Meridian Firs Apartments

Deck Repair

City of Puyallup
Development & Permitting Services
ISSUED PERMIT

PRDK20241966

2 DECK EDGE
SCALE: 3" = 1'-0"

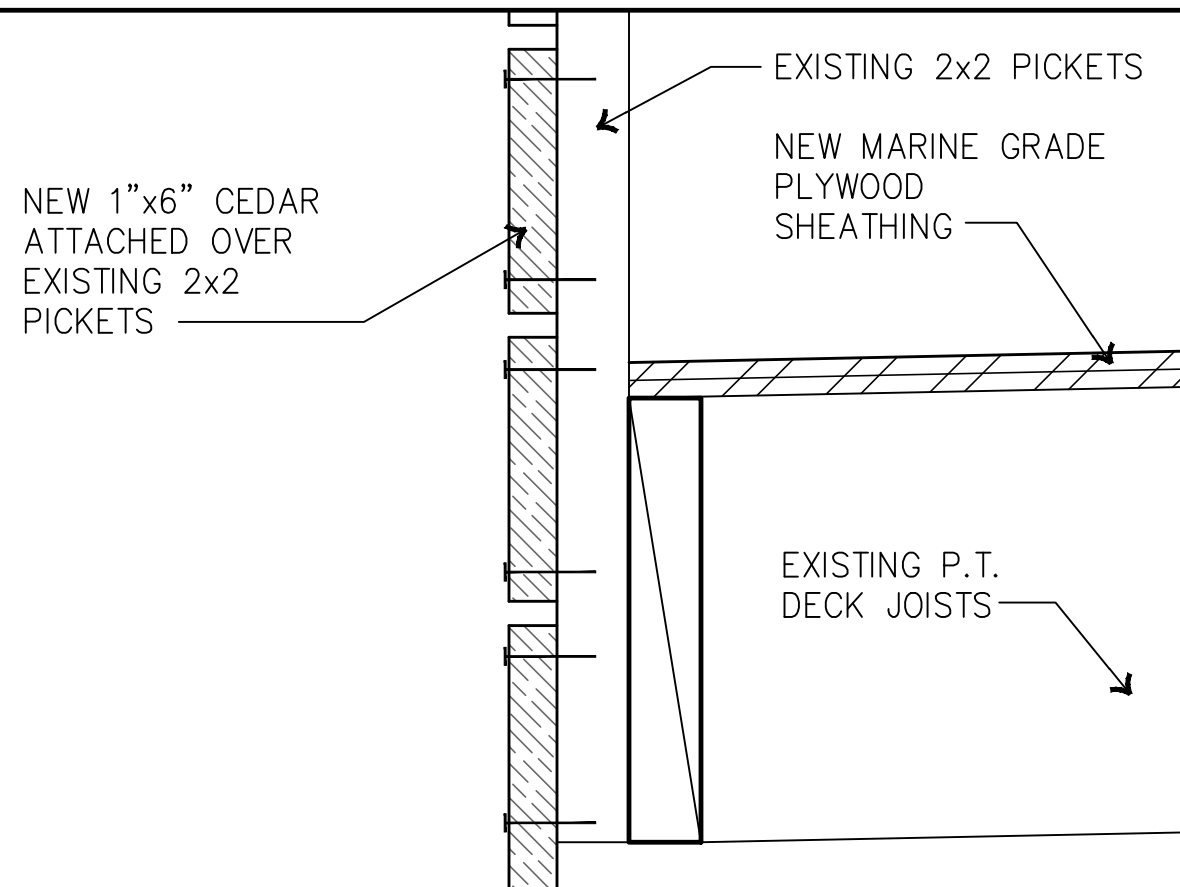
Add a notation on either Sheet A1.0 or A1.1 that contractor shall verify the integrity of balusters prior to the installation of the 1x6 cedar. Establish the parameters of the balusters replacement to include type, grade and nailing pattern.

1a COLUMN TO FOOTING
SCALE: 1 1/2" = 1'-0"

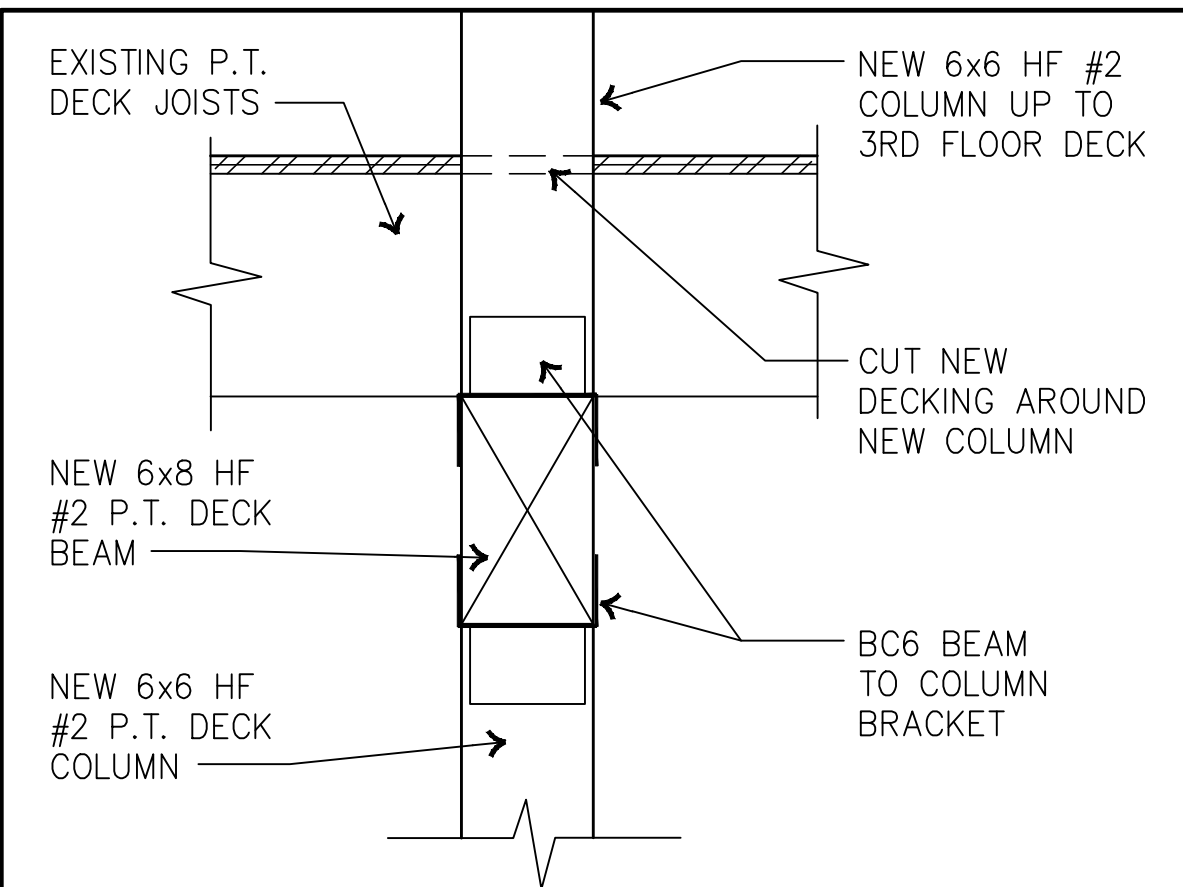
Detail the connection between the existing and proposed slab.

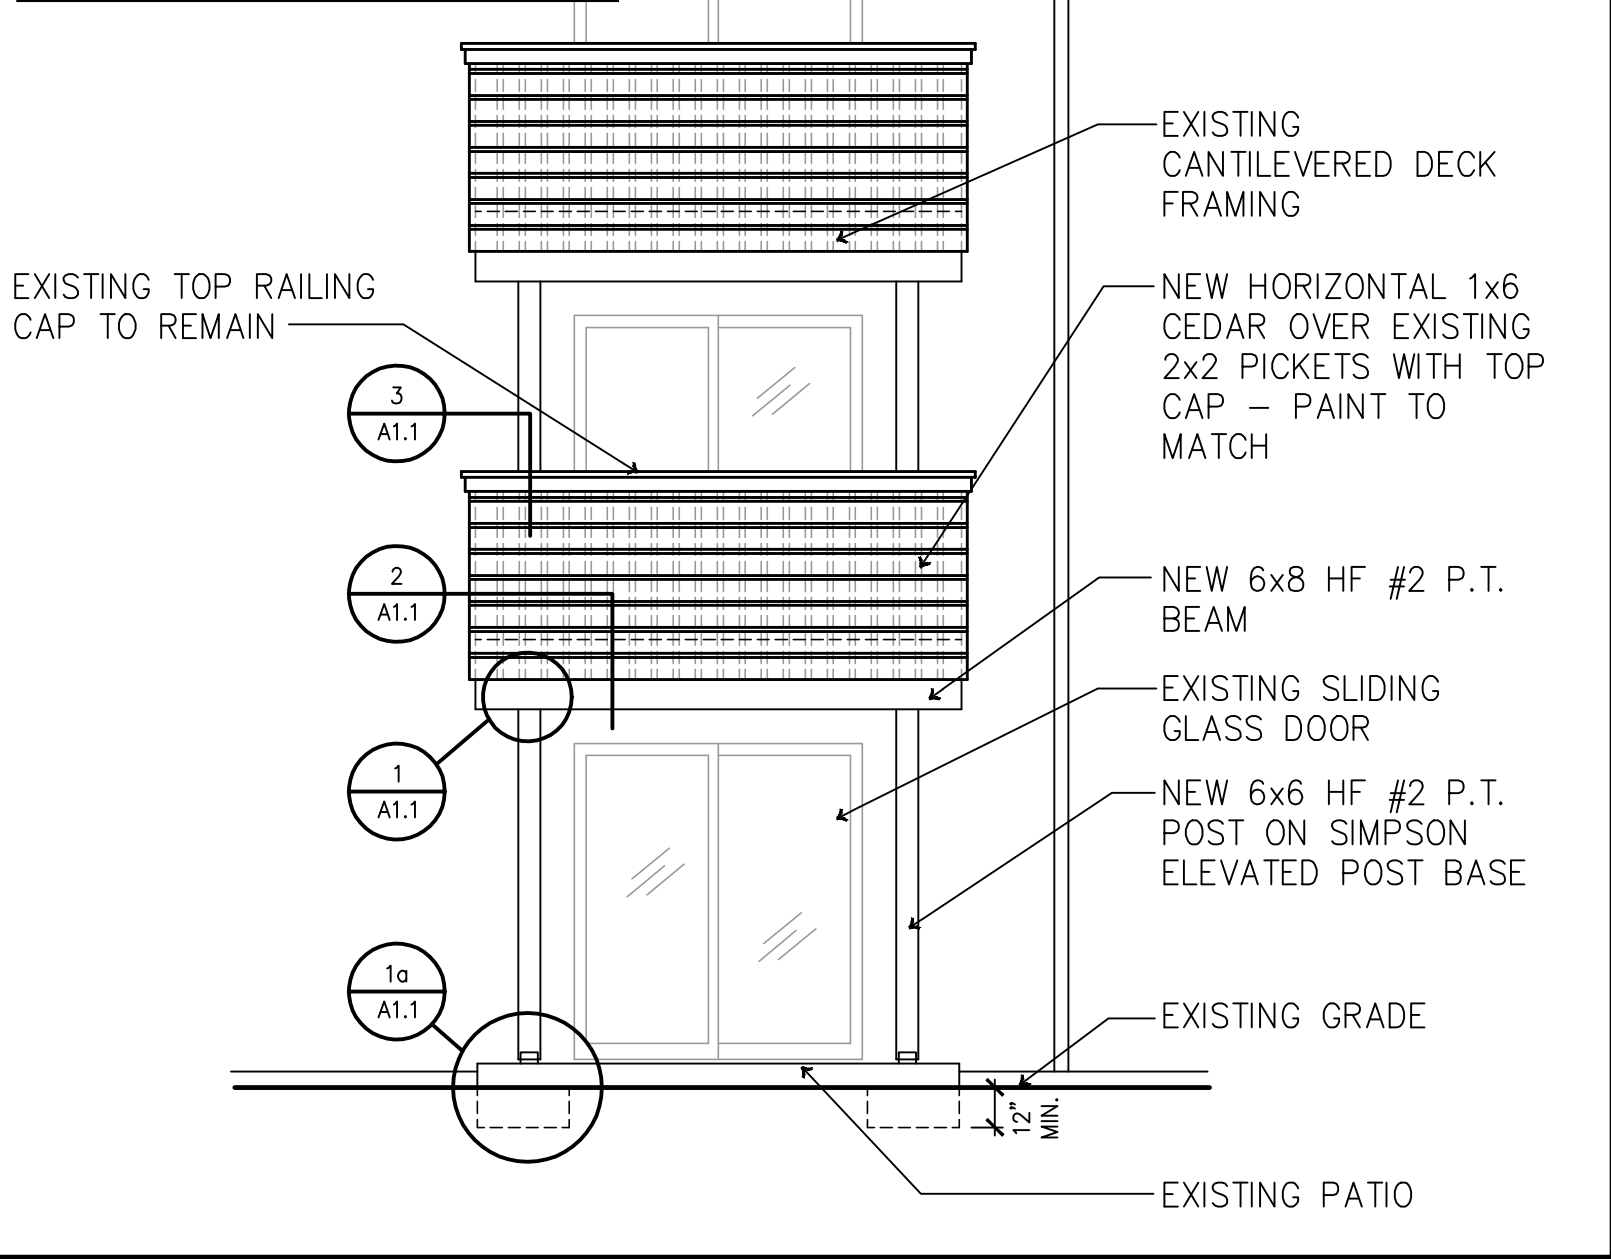
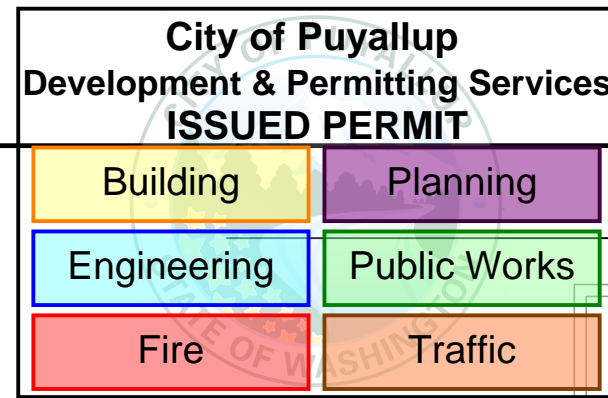
Deck joists appear to be sloped to drain off of the cantilevered side of each deck based upon details 1 and 2. Detail 2 shows the installation of the 1x6 cedar board over the existing 2x2 balusters. detail or notate how the 1x6 cedar will be installed to prevent drainage and water accumulation on the deck surface.

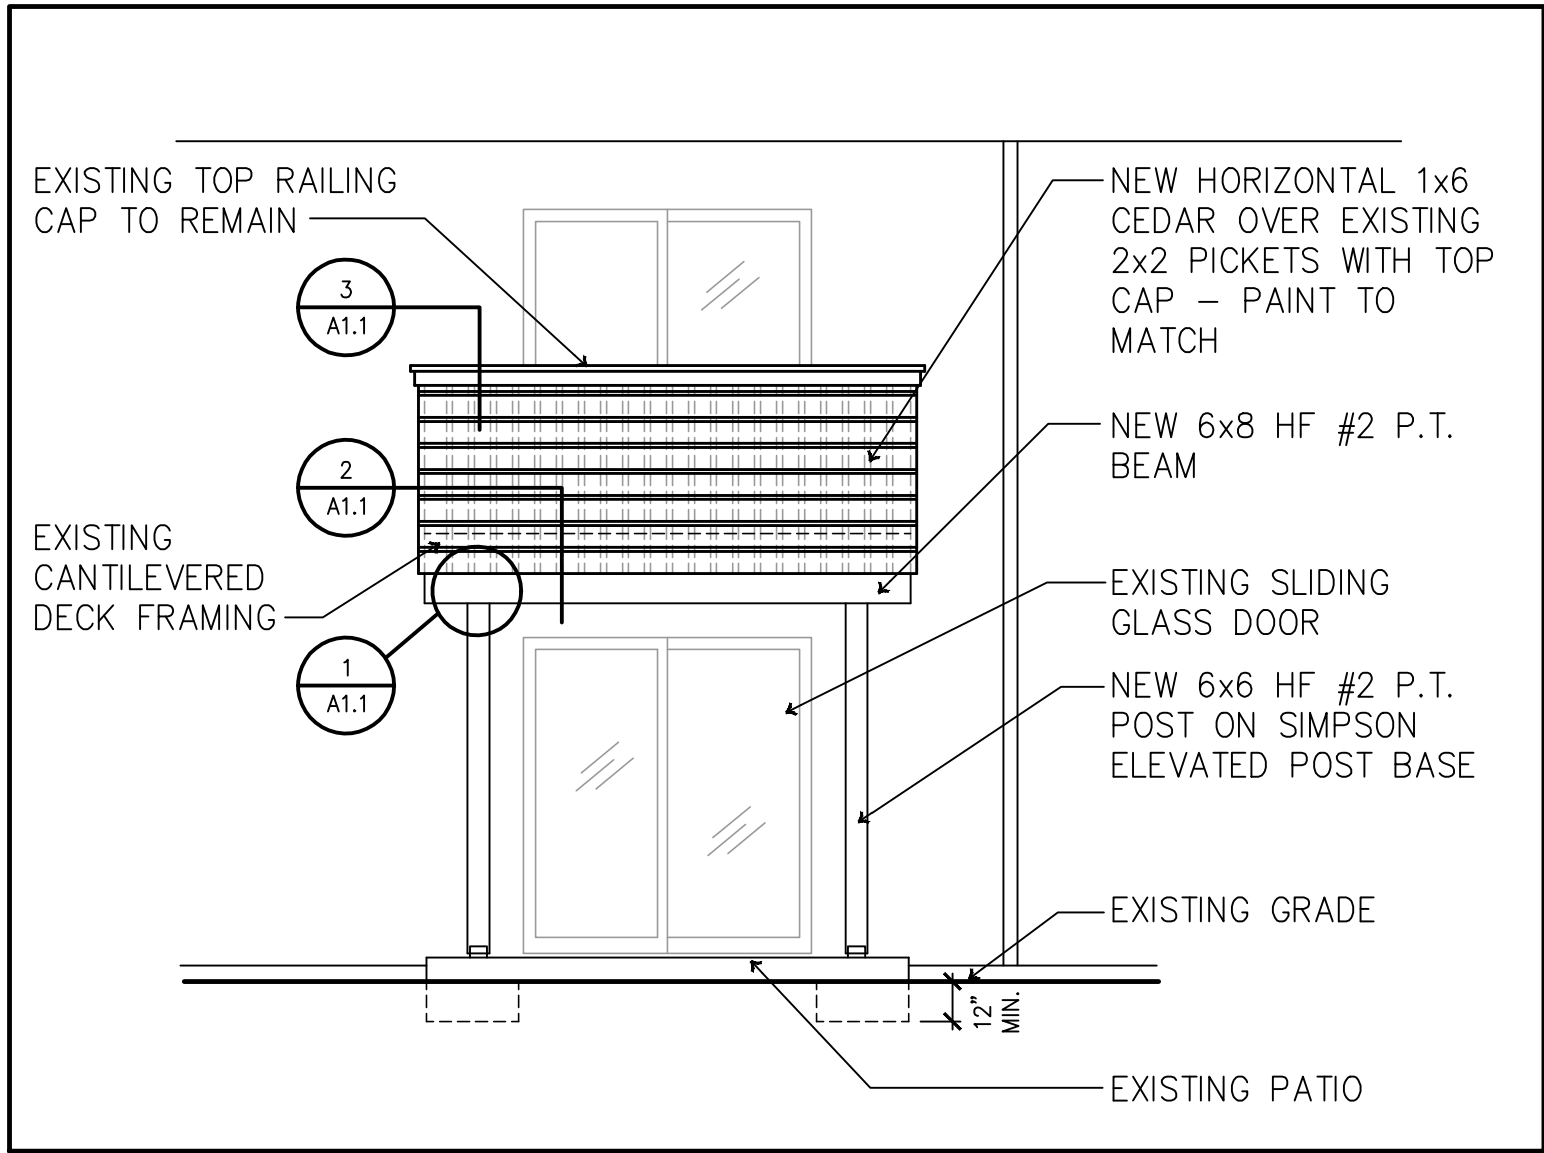
Provide specifics of the plywood that will be installed which should include plywood thickness, grade and any other specifics that will reflect that the plywood will withstand the dead and live loads of the deck. Identify the non-slip surface that will either be provided on the plywood or will be added to the plywood as part of construction, as notated on sheet A1.0, Owner/Contractor Coordination Notes.

The existing joist spacing should also be considered when selecting the plywood material that will be used. Please provide the existing joist spacing.

Updated all details and notes as needed to reflect the requested information.
